Illinois Tollway Base Sheet Revisions

Section M	Base Sheet Drawings	
	Drawing	**Modification Summary** **Effective: 03-01-2024**
	Roadway (RDY)-Series 400	
	M-RDY-407	**EARTHWORK AND GUARDRAIL SCHEDULE, SHEETS 1 and 2**

VERSION:	STANDARD:	SHEET:
2024-03	M-RDY-410	1 OF 7

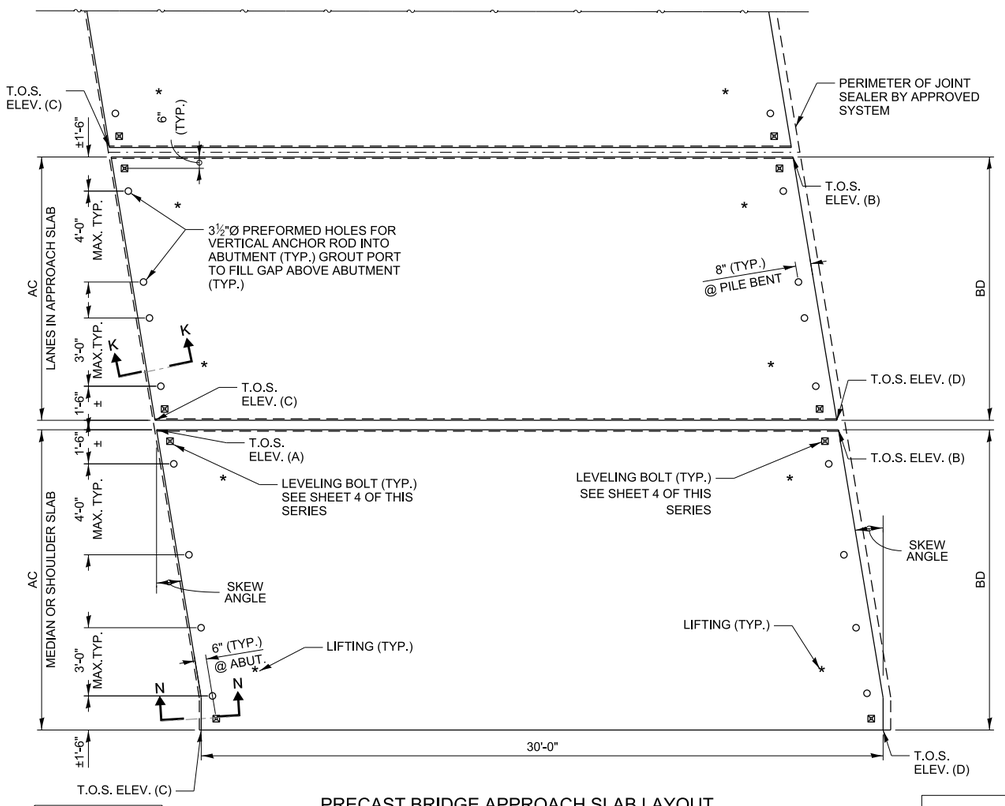
Sheet 3	Changed the note 8 to require fanned bars if skew angle is greater than 25º instead of 45º
	Sheet 4	Changed the callout for forms to require 2" thick foam sheet instead of 1/4" backer rod (detail H)
		Specified the 6" extension of forms beyond the UHPC joint (detail H)
	M-RDY-415	**LONGITUDINAL JOINT SEALANT**
		Added a new figure and 'NOTE TO DESIGNER' for 'TYPICAL LJS PLACEMENT - UNEQUAL SURFACE THICKNESSES'
	M-RDY-416	**ENVIRONMENTAL SOIL CLASSIFICATION**
		Added new note in 'NOTE' section regarding soil types.
	M-RDY-417	**MAINLINE TOLL PLAZA PAVEMENT DETAILS**

VERSION:	STANDARD:	SHEET:
2024-03	M-RDY-417	1 OF 3

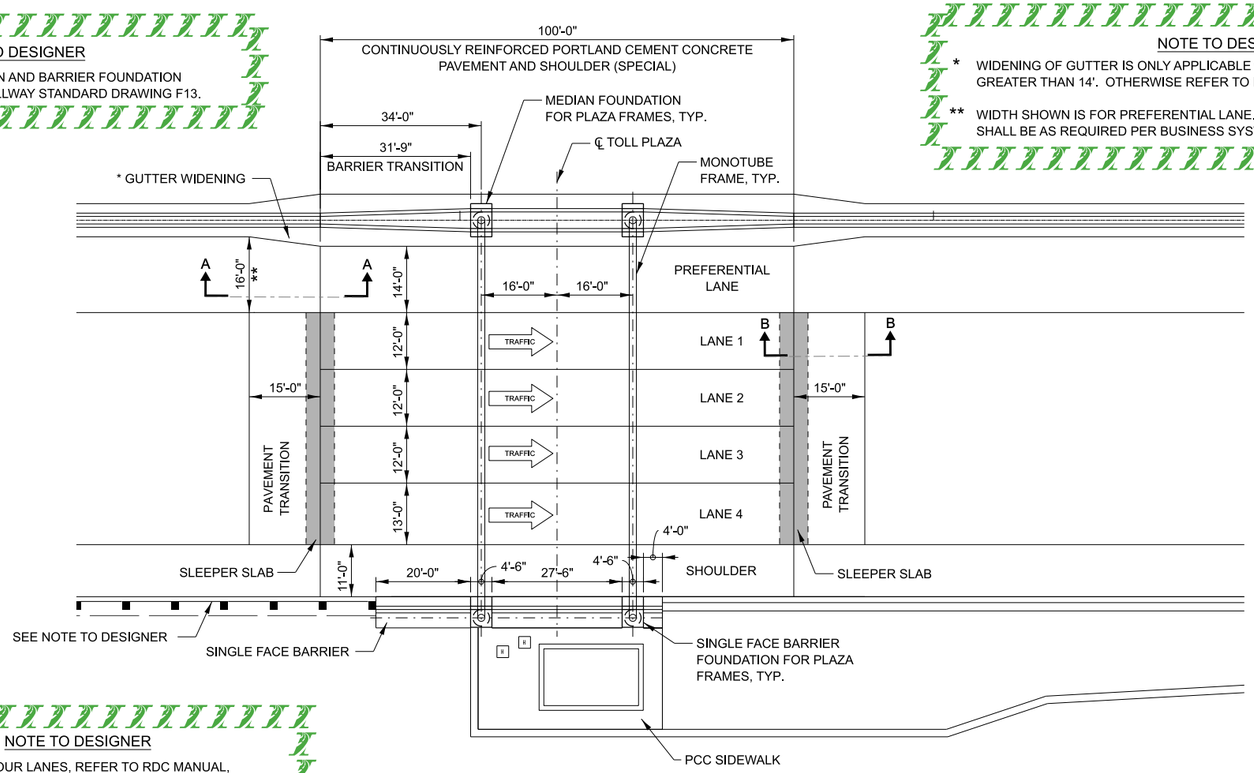
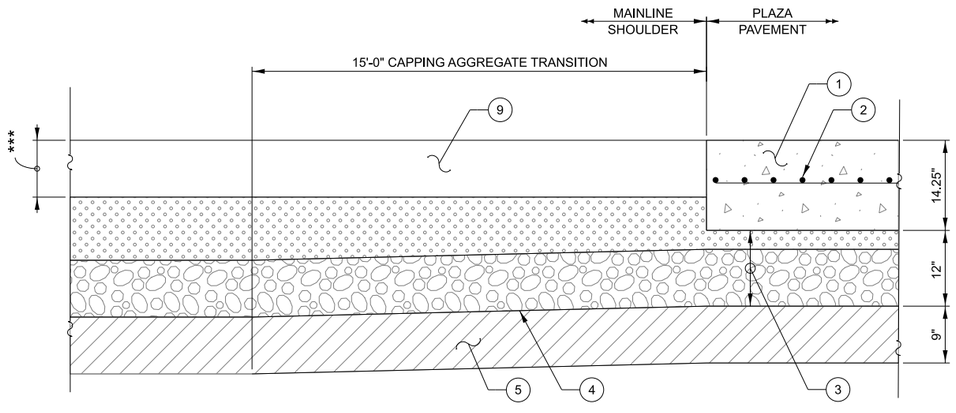
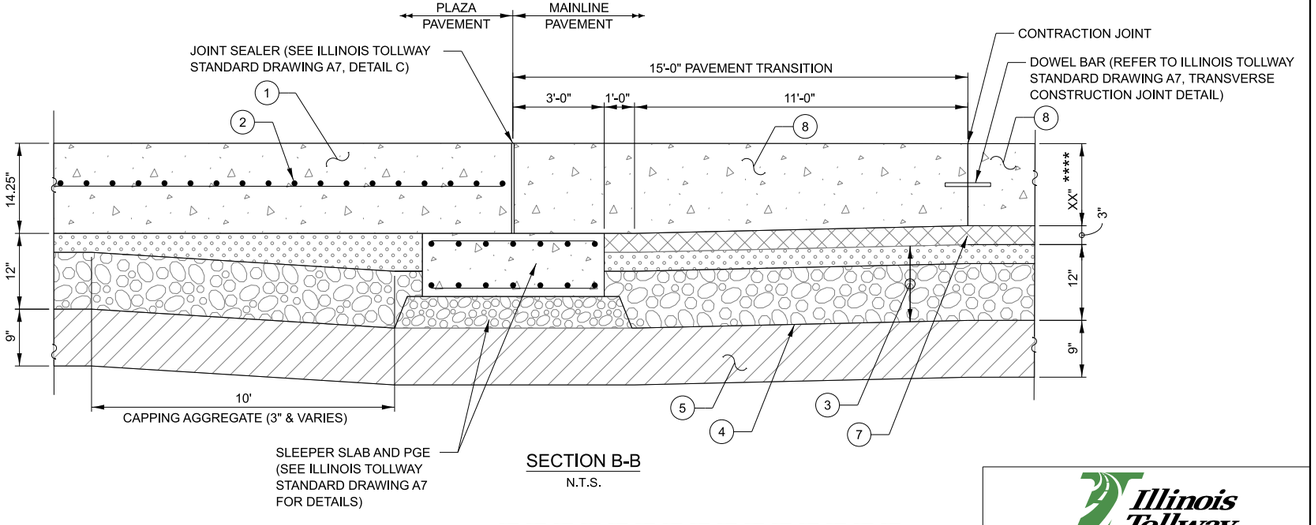
Sheet 1	Added a call-out and 'NOTE TO DESIGNER' for PCC Sidewalk.
	Sheet 2	Clarified concrete barrier call out in Section A-A.
	M-RDY-418	**RAMP TOLL PLAZA PAVEMENT DETAILS**

VERSION:	STANDARD:	SHEET:
2024-03	M-RDY-418	2 OF 3

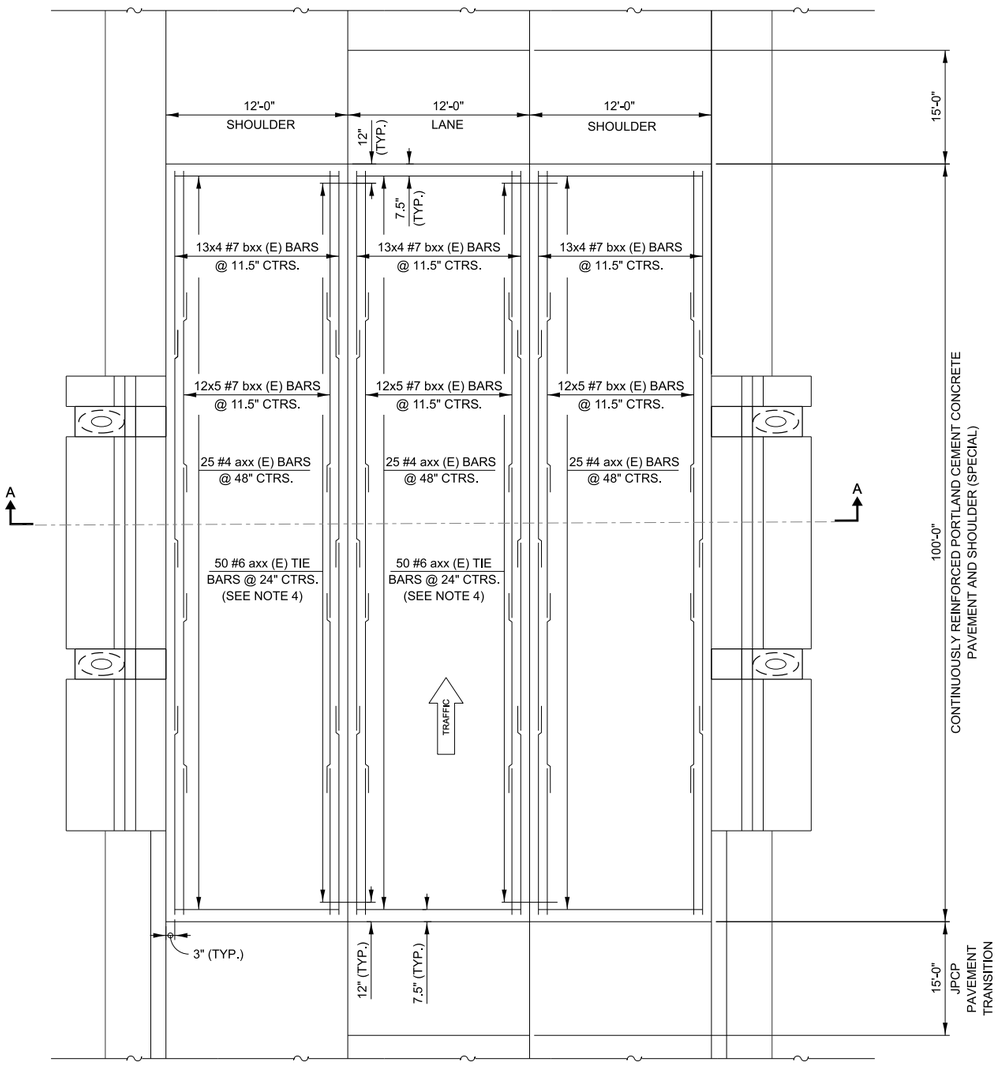
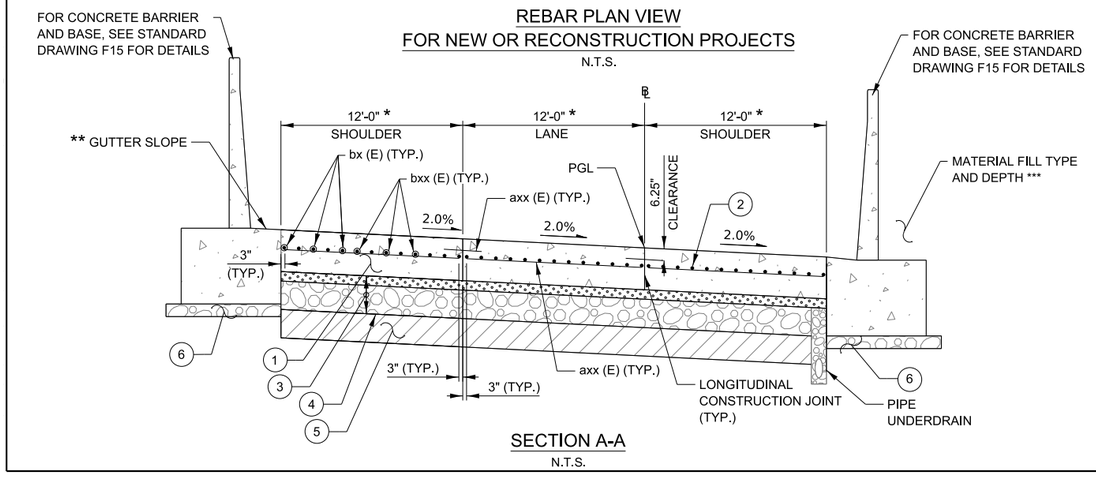
Sheet 2	Added a call-out and a note in 'NOTE TO DESIGNER' regarding material fill type and depth when adjacent to existing pavement.
		Clarified concrete barrier call out in Section A-A.
